Courtyard enclosure study · closing the conditioned house around the open courtyard · Taif / Palm House V7.1

Design review Y-01 (critical) · 30 Oct 2026 · the windows follow `docs/DESIGN_LANGUAGE.md` (black steel, divided lites)

DECIDED: option A (owner, 30 Oct 2026, applied in V7.0): the projection 1.55 m, B3 / R11 / C21–C23 at x 5.80, W1 / W2 / W3 as in § 2. The "now" column below is the V6.3 state (edge x 5.60), kept as the record of the comparison.

Plans of the gallery strip, first floor · now / A / B · the sky opening and the void · about 1:115 on A4

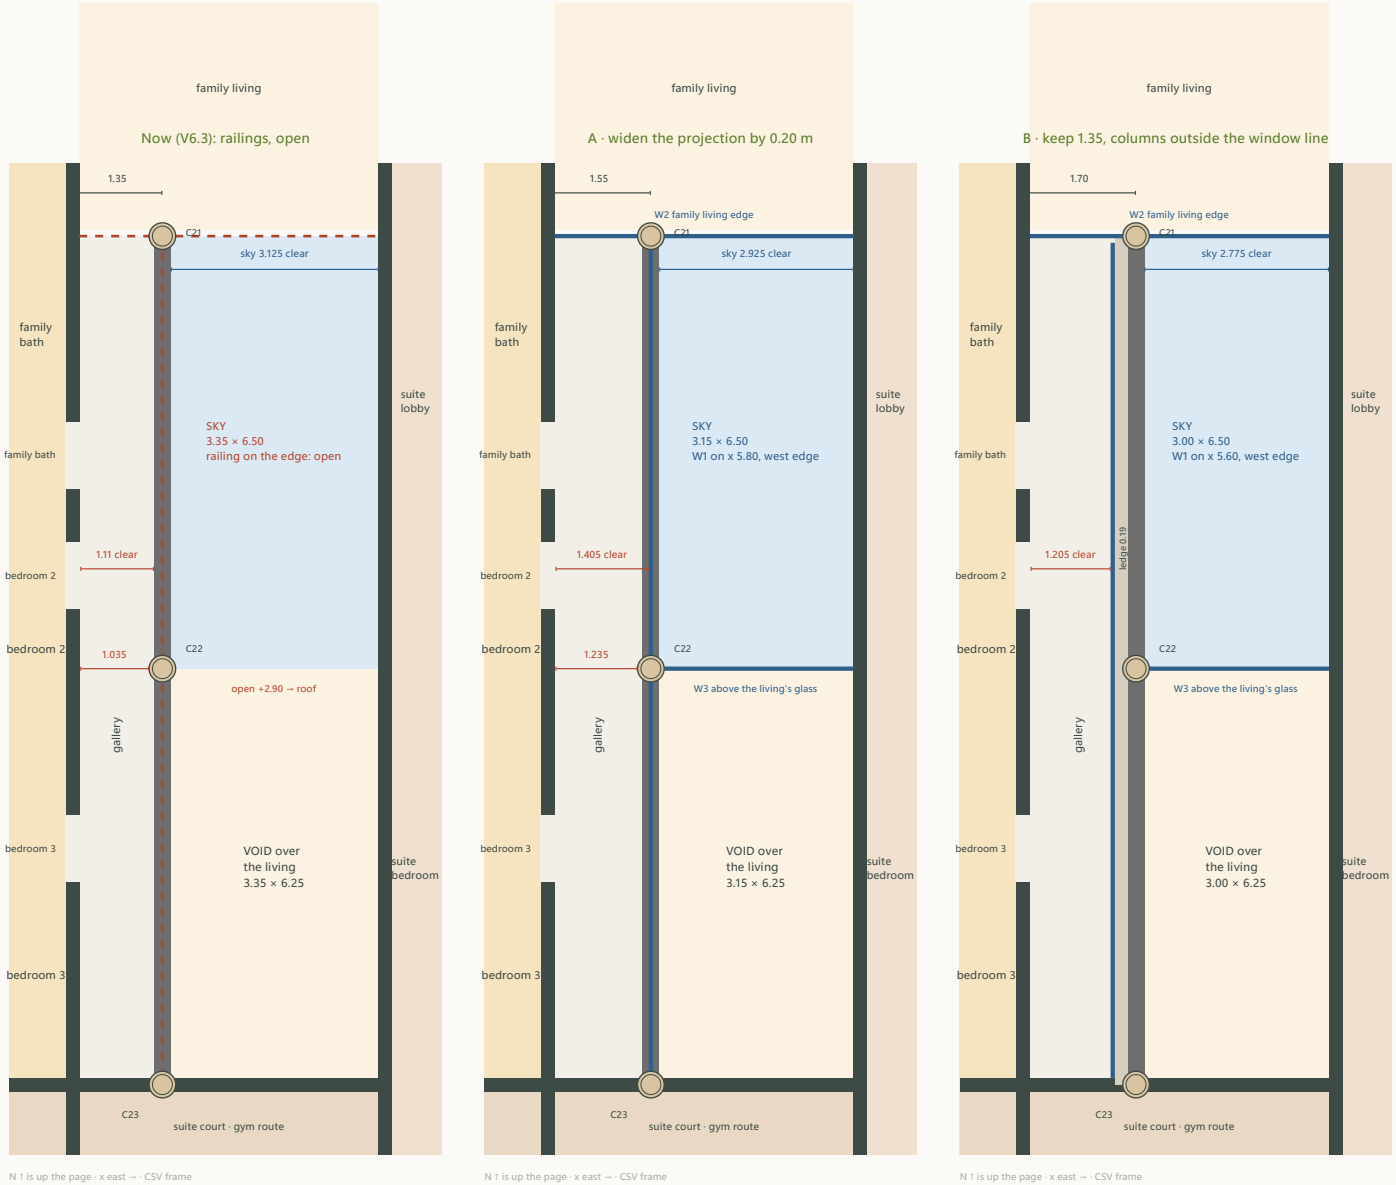
Today the gallery is 1.11 m clear between the rooms' finished wall face (x 4.365) and the upstand of B3, and 1.035 m at the three stone column sleeves (Ø0.4). A window on the line changes little by itself; the columns are the problem. Two ways to reach 1.20 m:

4 · Recommendation: A **A** keeps everything on one line: the beam, the columns, the window and the railing base are the same element, the gallery is 1.405 m clear and 1.235 m at the columns, the sky loses 6 % of its area and stays 3.15 m wide on axes. **B** reaches 1.20 m with no margin (1.205 m), narrows the sky more (3 m: the beam and the roof edge must follow the columns), and adds a 0.35 m ledge outside the glass that must be waterproofed, capped and kept clean; its one real gain, free-standing columns in front of a glass wall, is a stronger colonnade image. If the owner wants that image, B is buildable; otherwise A. In both, the two-storey columns, the upturned B3 and R11 stay as decided (X8); only their x changes. **Study checks passed** (7)

Sections through the courtyard (y ≈ 10, looking north) · A and B · about 1:105 on A4

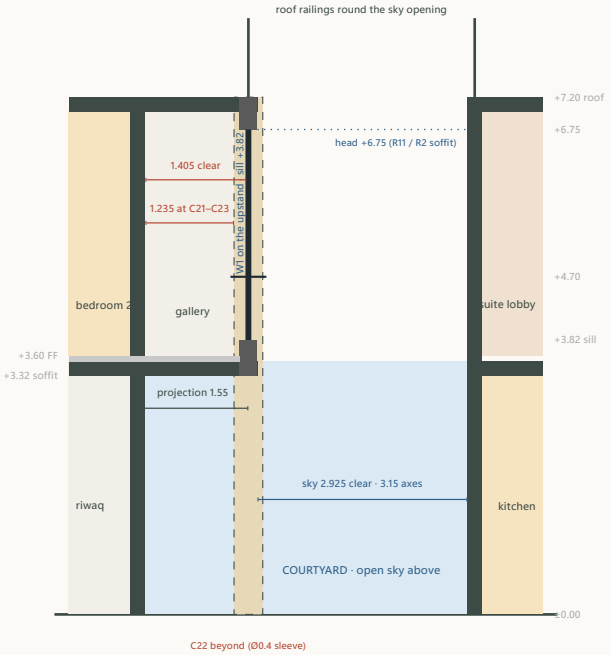
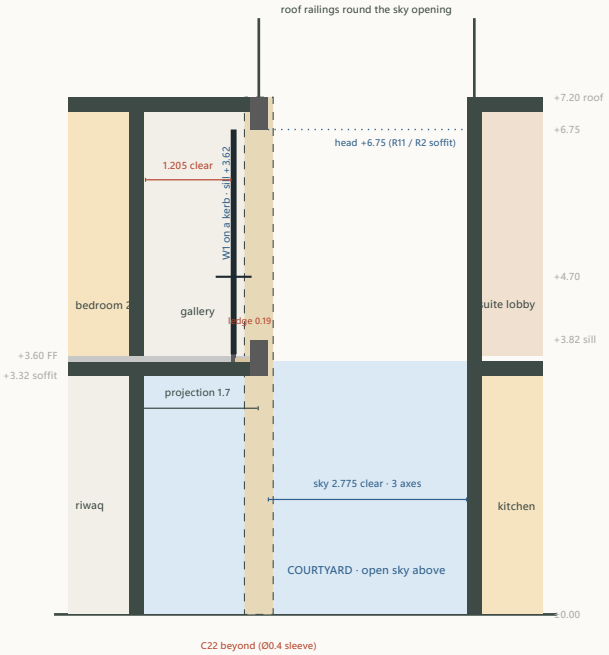
Both options. W1 bears on the upstand of B3 (the window's dead load is small; the upstand becomes its sill and its anchor, 0.25 wide); W2 on B2 (floor-level sill, the frame anchored to the slab edge and R1); W3 spans +2.90 → +6.75 between C22 and the kitchen wall, held top and bottom (R2 above; a steel transom at +3.82 tied to C22 and the wall takes the wind of the 3.85 m height; the courtyard well has little wind). The head line is the soffit of R1 / R2 / R11 at +6.75 over the void (y 13–19.25) a 0.25 m fascia keeps the same line under the roof slab. Nothing new for the engineer except the window anchors and, in B, the ledge.

- **A:** B3, R11 and C21–C23 move 0.20 m east to x 5.8 the projection slab bay becomes 1.55 m (slabs-ff row "the projection"), the roof strip over the gallery 1.55 m (slabs-roof); C22 stays the pier in the living's courtyard glass (now at x 5.8), C21 in the women's majlis glass, C23 in the living's south wall; the spans (6.5 / 6.25) are unchanged, R2's west end lands on C22 at x 5.8. The sky opening is 3.15 × 6.5 m.

- **B:** B3, R11 and C21–C23 move 0.35 m east to x 5.95 the slab bay becomes 1.7 m with the window line 0.35 m inboard of the beam on a 0.10 m kerb; the ledge between the kerb and the upstand is waterproofed and capped (stone, falling out). The columns stand free in the courtyard and in the void: C22 is a free column in the living's courtyard glass line, 0.35 m in front of the upper window W3 (W3 then runs behind it, from the W1 line at x 5.6 to the kitchen wall, 3.25 m). Alternative B2 (not recommended): B3 stays at x 5.6 and reaches the columns at x 5.95 on short corbels; two lines of concrete for one edge.

Dark: walls, slabs, the roof; grey: the upturned edge beam B3 (0.25 × 0.50 total, 0.30 above the slab) and the roof edge beam R11 above it; the dashed column is C22 (y 13.0) beyond the cut. W1 (heavy black line) sits on the upstand (A) or on a 0.10 m kerb inboard of it with a stone-capped ledge outside (B); its guarding transom at +4.70, its head at +6.75 under R11.

W1 · the gallery line seen from the courtyard and the void (looking west) · option A · 1:70 on A4

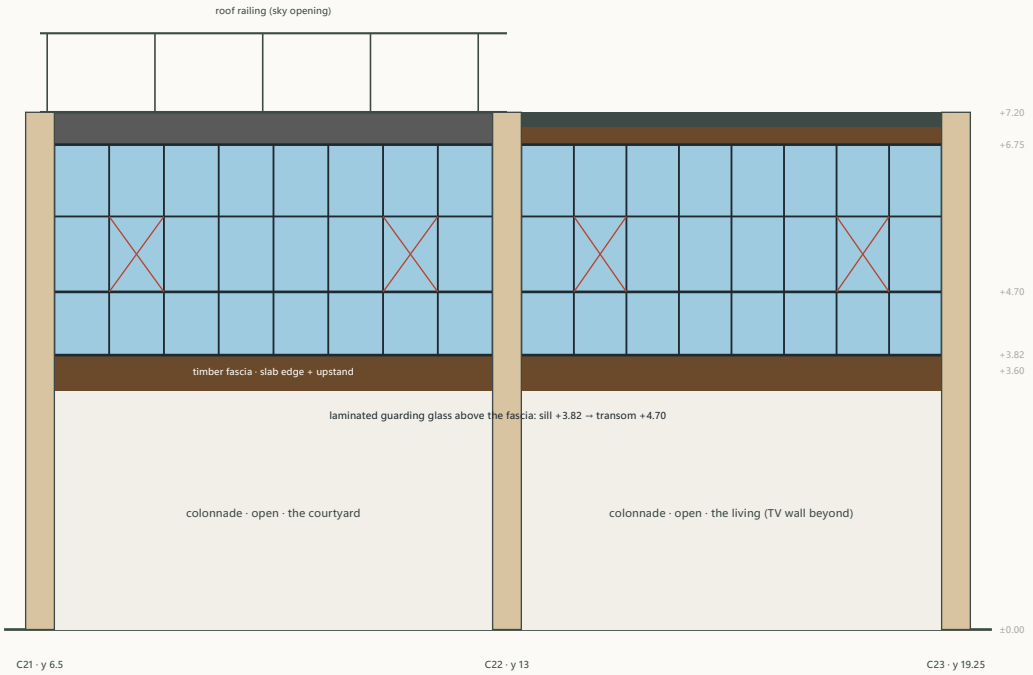
V7.1 (owner, 31 Oct 2026): semicircular heads and the courtyard arcade. Every enclosure window gets a semicircular (Roman) arched head in black steel with divided lites, the arched head fixed, the rectangular part below with the operable lites; the sill and the guarding transom (+4.70) as in § 2. **W1:** six arched windows 1.60 m wide on the gallery edge, three per column bay, sill +3.82, springing +5.80, crown +6.60, 0.15 m of wall below the R11 / R2 soffit (+6.75): in the courtyard bay they stand over the three bays of the new arcade (y 6.783–8.383, 8.950–10.550, 11.117–12.717), in the void bay on three equal bays (13.242–14.842, 15.325–16.925, 17.408–19.008); the four casements sit in the lower parts. **W2:** two arched windows 1.30 m wide east of C21 (x 6.00–7.30 and 7.55–8.85), floor to the crown +6.60, springing +5.95; the strip x 4.25–5.80 of that edge is the family living's opening to the gallery's north end, no window. **W3:** one arched window 2.80 m wide (the whole space between C22's stone sleeve and the east wall; the brief said ≈ 3.0) over the living's courtyard glass, +3.32 to the crown +6.60, springing +5.20, the two motorised tilt lites in its lower part; 0.15 m of wall to the R2 soffit. **The arcade:** in the courtyard bay only, two slender honey-stone columns Ø0.25 on x 5.80 at y 8.667 and 10.833 (three equal bays of 2.167 m on axes) with three semicircular arch plates under the projection's soffit (+3.27): spans 1.84 / 1.92 / 1.84 m between the sleeves, springing +2.35 / +2.31 / +2.35, crown +3.27; decorative unless the engineer uses the columns (`studies/structure.typ` X18); the living bay keeps no arches. The columns stand 0.78 m clear of the sunken seating's west edge, 1.36 m clear of the riwaq door's swing line, 1.33 m from the riwaq glass face; the malqaf outlet is on the east wall. The courtyard reads as a two-tier arcade: three arches below, three arched windows above.

black steel, divided lites ≈ 0.75 wide · transoms at +4.70 (guarding) and +5.75 · red X = inward side-hung casements, two per bay (night mode, cleaning) · about 35.01 m² of glass · A · widen the projection by 0.20 m
